**CONSTRUCTION CONTRACT CHANGE ORDER NUMBER:** \_\_\_\_\_

CCSJ:	<u>0921-02-321</u>
Project:	<u>STP 2021(256) MM</u>
Highway:	<u>Mile 3 N</u>
County:	<u>Hidalgo</u>
District:	<u>21-Pharr</u>
Contract Number:	<u>C-20-294-02-23</u>

## Change Order #5 Mile 3 N Road

Project: Mile 3 N Road  
Project #: STP 2021 (256) MM  
Contract: C-20-294-02-23  
CSJ: 0921-02-321  
Limits: Tom Gill Road to FM 492 (Goodwin Road)

**MILE 3 ROAD  
 UTILITY AND DRAINAGE  
 STA. 150+50 TO STA. 155+50**

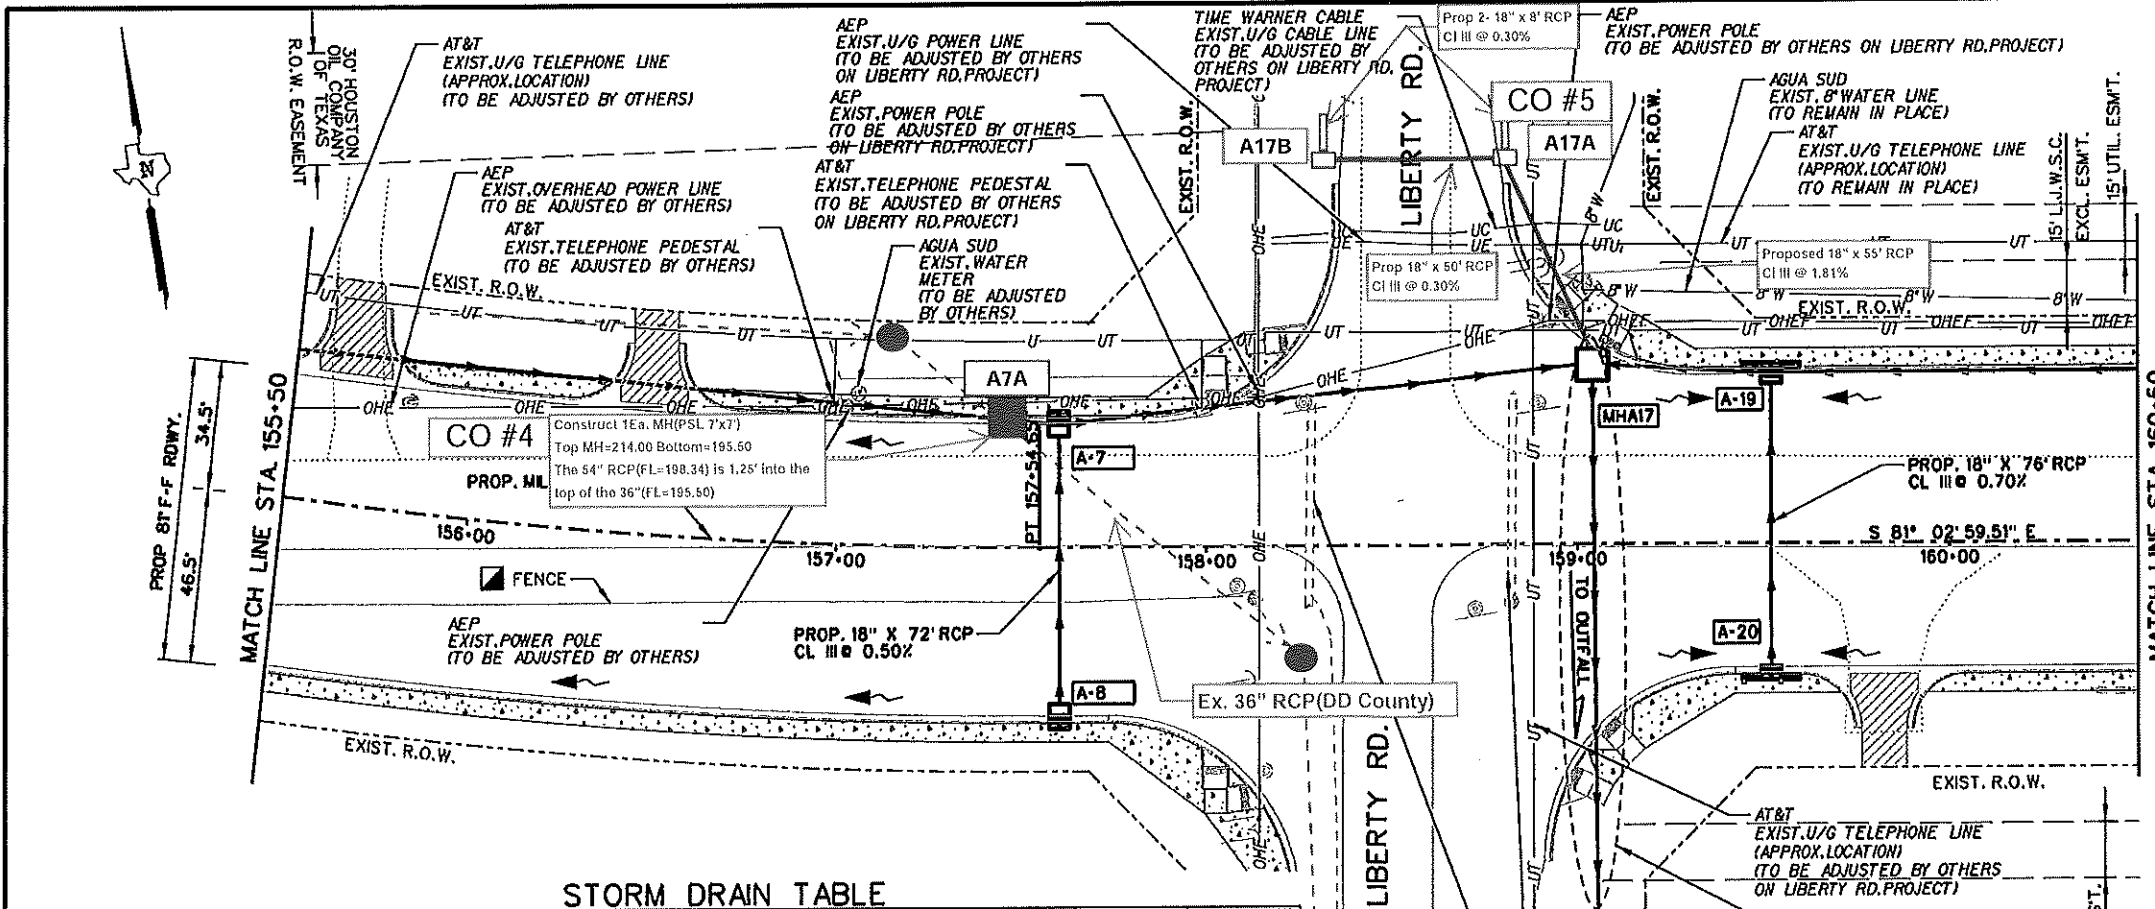
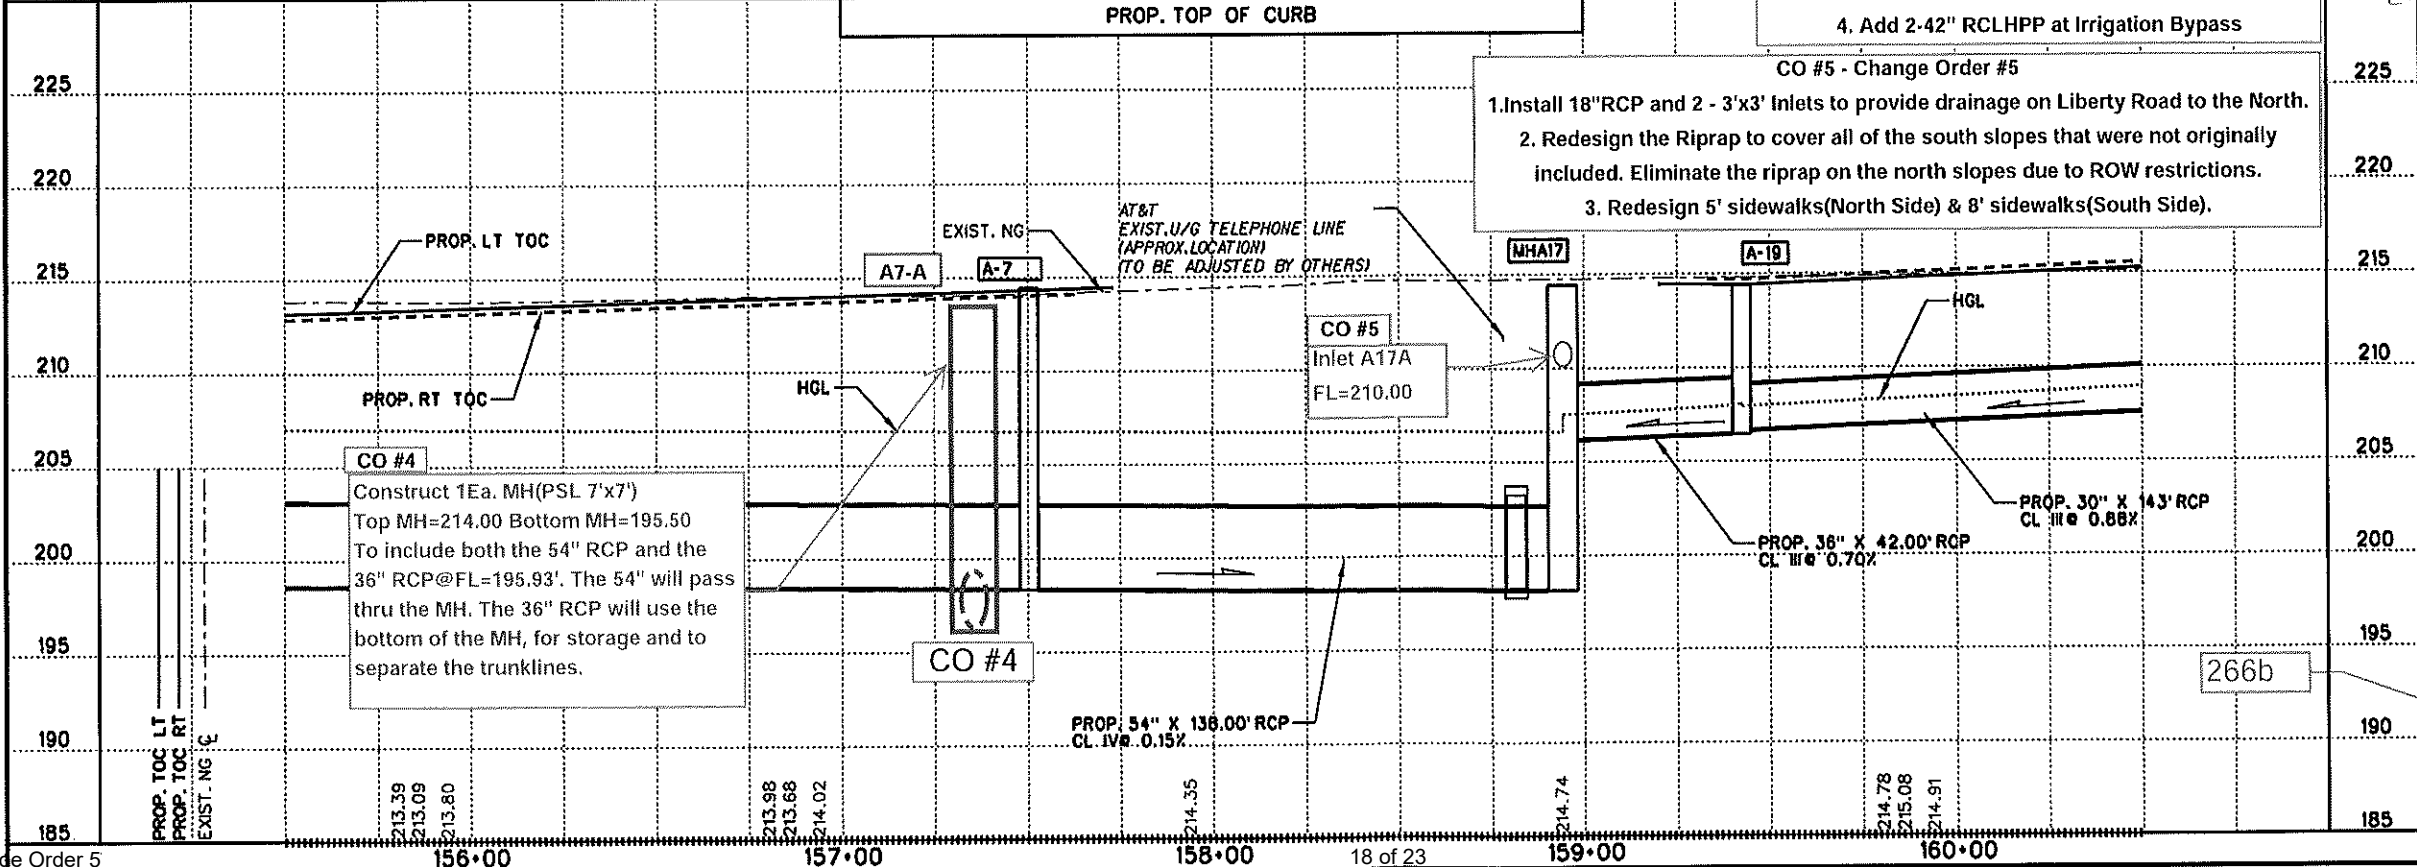
- CO #5 - Change Order #5**
1. Install 18" RCP and 2 - 3'x3' Inlets to provide drainage on Liberty Road to the North.
  2. Redesign the Riprap to cover all of the south slopes that were not originally included. Eliminate the riprap on the north slopes due to ROW restrictions.
  3. Redesign 5' sidewalks (North Side) & 8' sidewalks (South Side).

**MILE 3 ROAD  
 PLAN AND PROFILE  
 STA. 195+50 TO STA. 200+50**

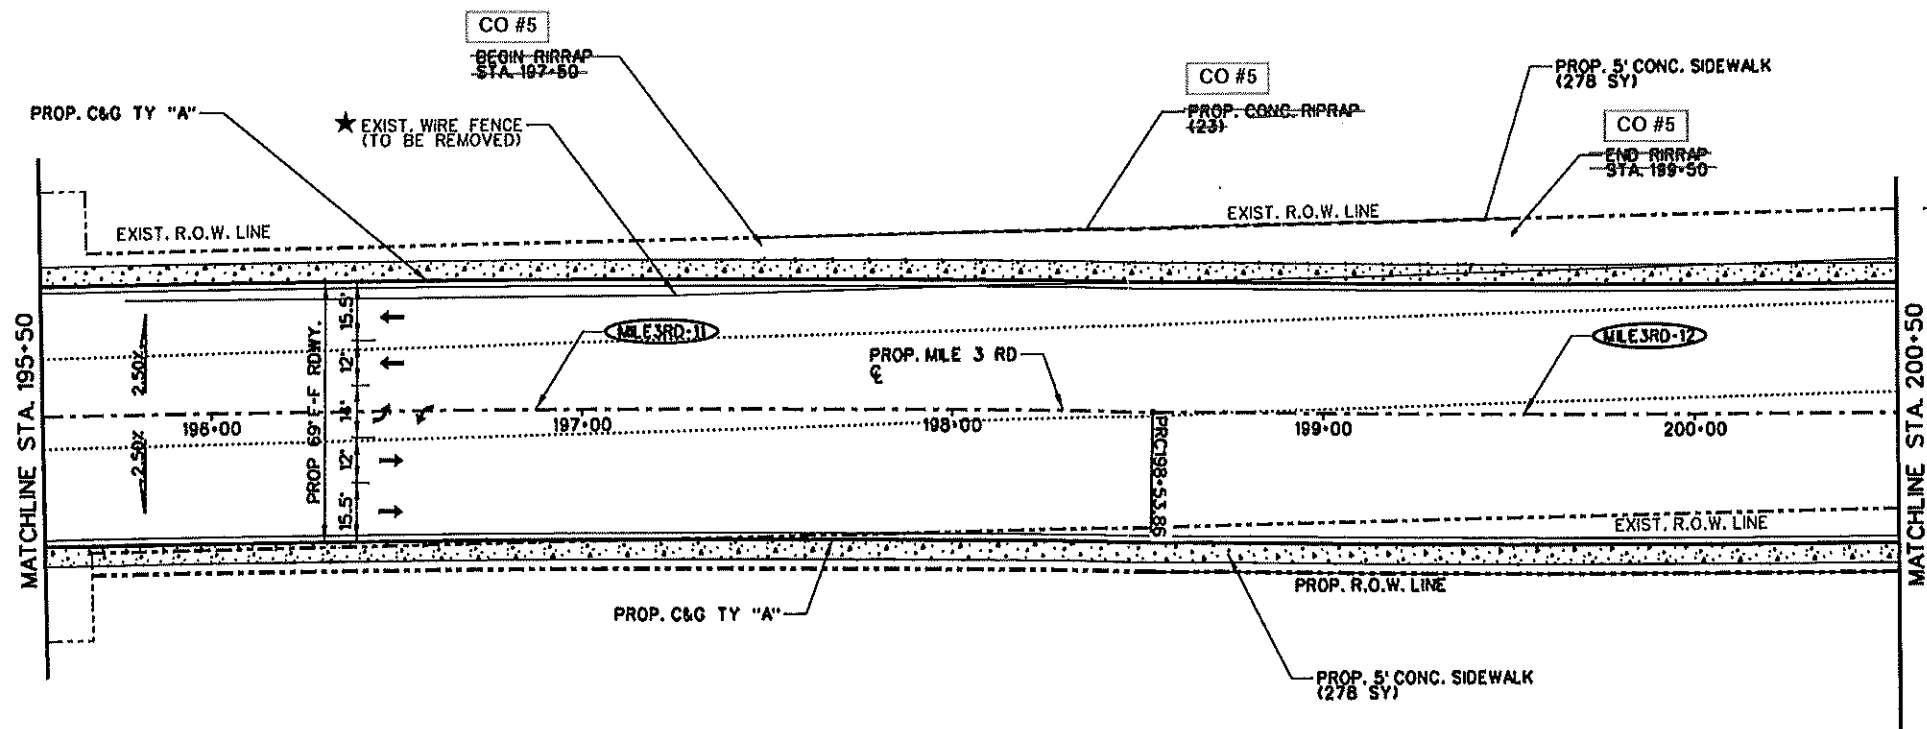
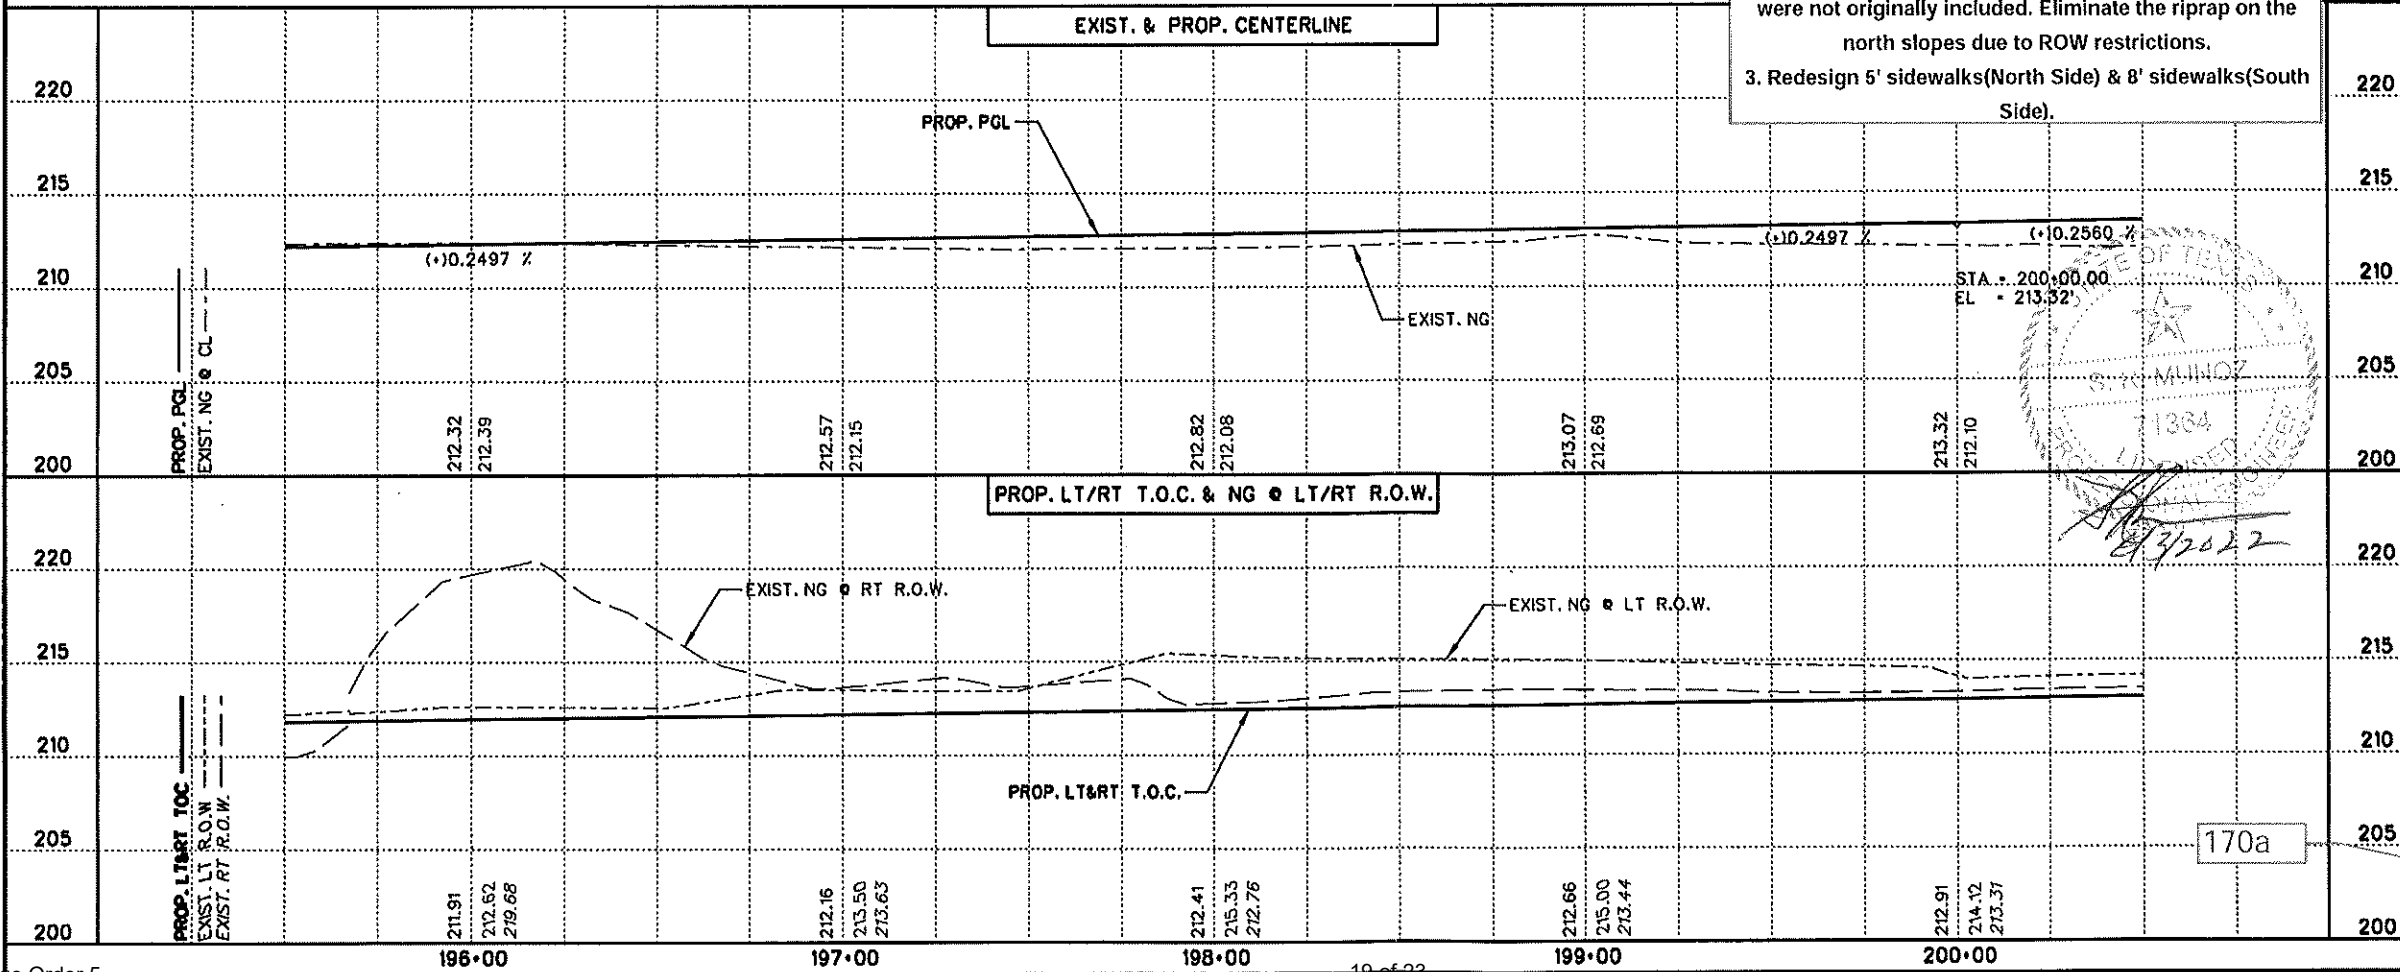
1. Install 18" RCP and 2 - 3'x3' Inlets to provide drainage on Liberty Road to the North.
2. Redesign the Riprap to cover all of the south slopes that were not originally included. Eliminate the riprap on the north slopes due to ROW restrictions.
3. Redesign 5' sidewalks (North Side) & 8' sidewalks (South Side).
